The Battery

SBR096 – SBR256

Premium Version vs. V0 Version

Andrea Polini – 06.01.2022

Packaging

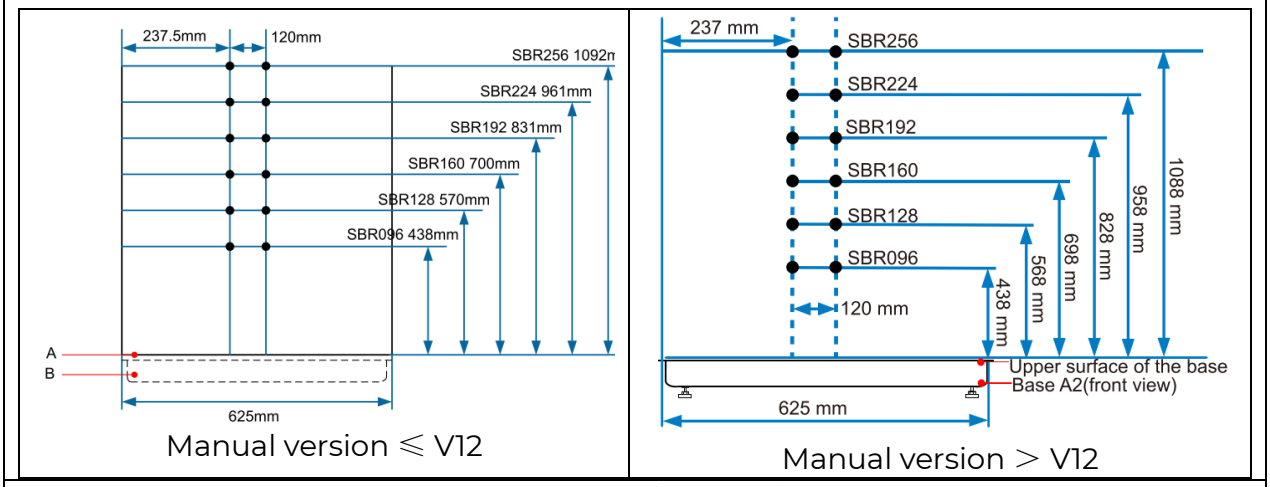
The Premium logo is added on the packaging for distinction.

All the premium products including the battery module and accessary add Premium stickers	The V0 Product does not have the Premium logo.

Battery Module

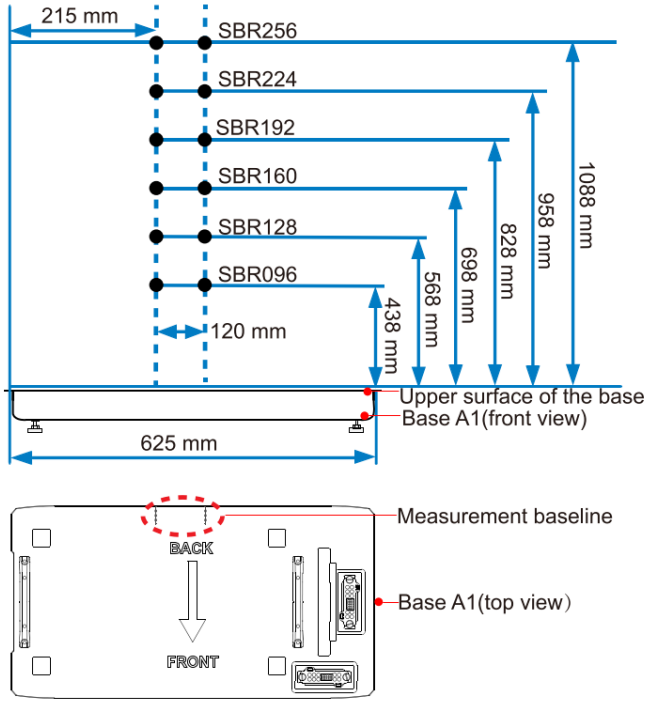
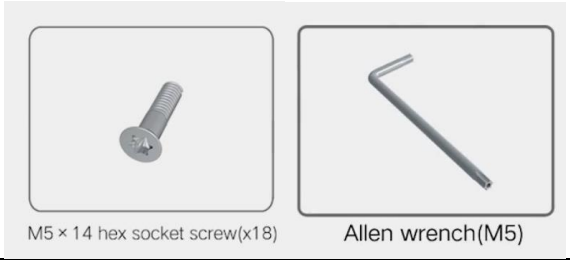
The position of the holes for the mounting bracket are different in the Premium battery module. V0 is 237.5mm from the side, while Premium is 215mm from the side.

V0 version Screws	Premium version screws

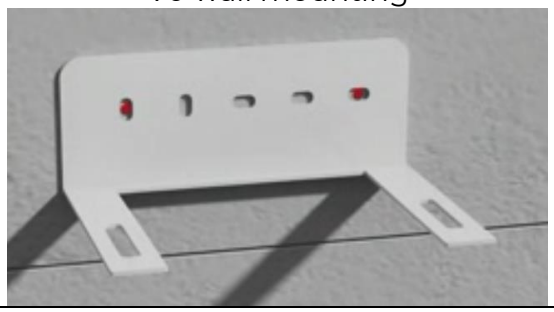
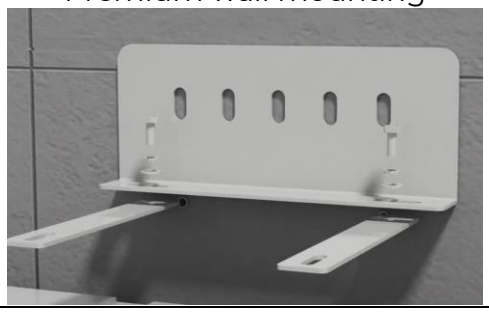
The V0 Battery Module and Accessory contain cross screws, while the Premium contains only Hex screws. This is a meaningful difference for the installation (also compared to the EU installation video)

Side Breaker

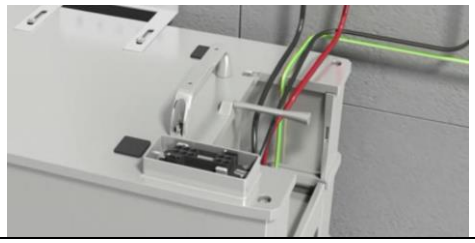
The Premium Version side breaker has a different arrangement of the connector, and a different breaker model compared to V0.

Top Cover

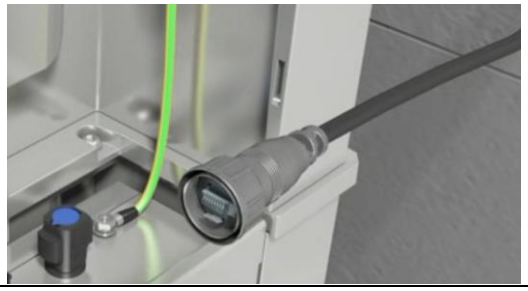
The Premium top cover has a round hole at the back side and it has a new design LED light.

Communication Cable

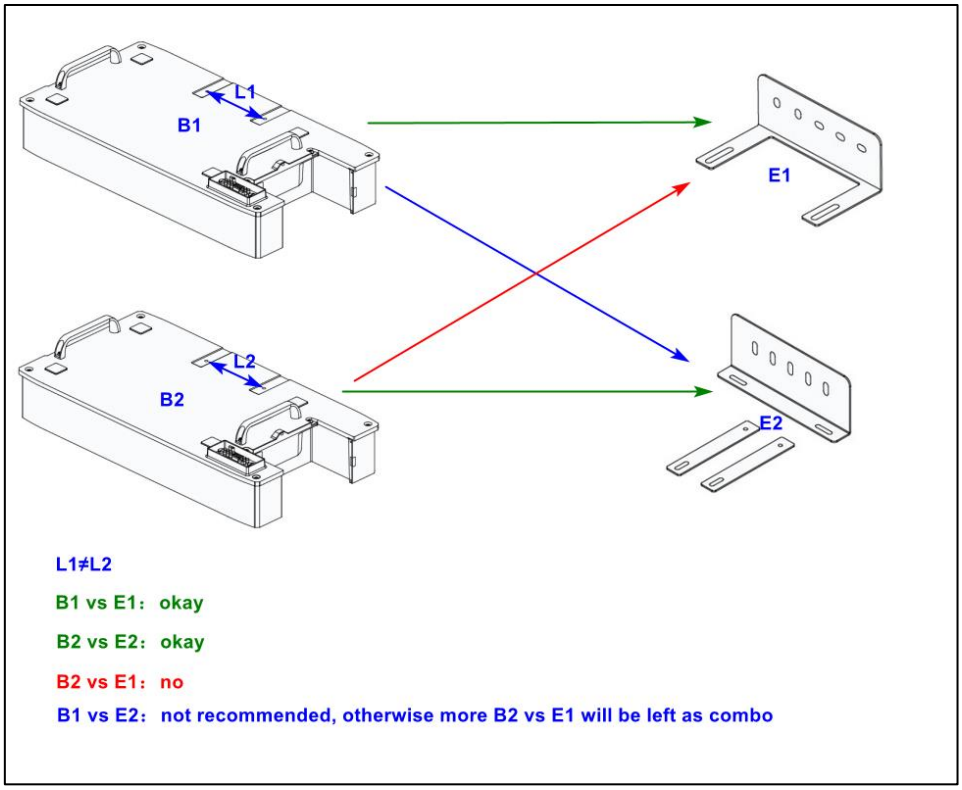
V0 version provided the communication cable already assembled with a RJ45 terminal. The Premium version provides a naked CAT5 cable and separated RJ45 terminal.
